Re: Appeal of FEMA's Preliminary Flood Insurance Rate Maps for New York City

# APPEAL OF FEMA'S PRELIMINARY FLOOD INSURANCE RATE MAPS FOR NEW YORK CITY

**By the City of New York**

**Mayor's Office of Recovery and Resiliency**

Figure 5-7. Comparison of the 1-percent-annual-chance floodplain extents between the FEMA's PFIRM coastal analysis and the City's analysis for the Canarsie neighborhood in Brooklyn.

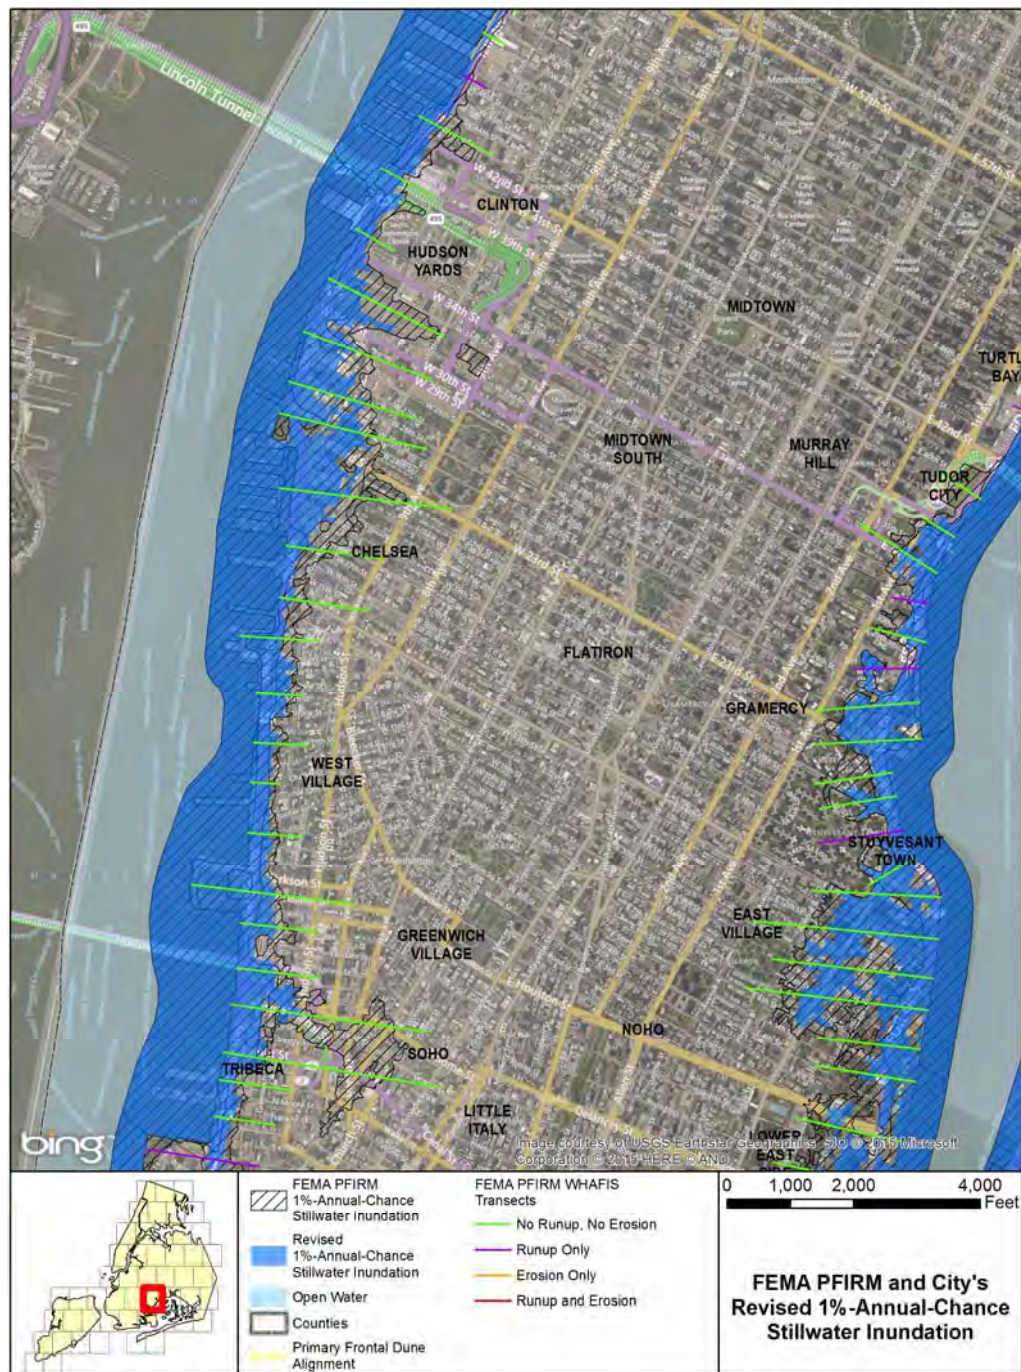
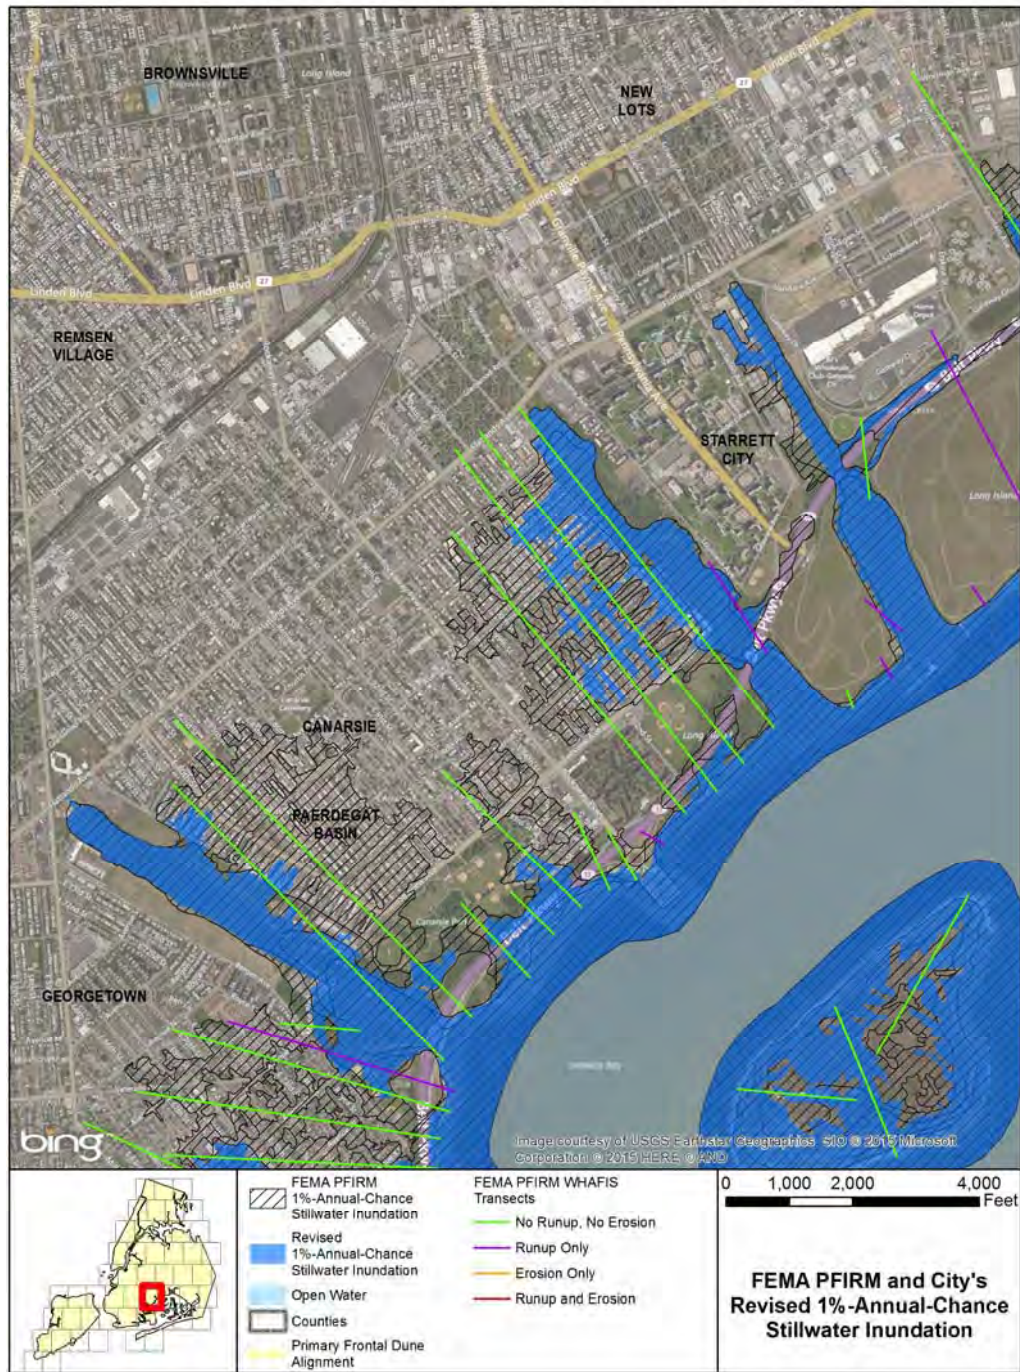
Another neighborhood significantly impacted by the changes in SFHA boundaries based on 1-percent-annual-chance stillwater elevations in the City's analysis is the Canarsie neighborhood in Brooklyn, as shown on Figure 5-7. The topography in the neighborhood is generally in the range between the 1-percent-annual-chance stillwater elevations determined by the City's analysis and those elevations determined by FEMA's PFIRM analysis, making the floodplain extents sensitive to the difference in stillwater elevations.
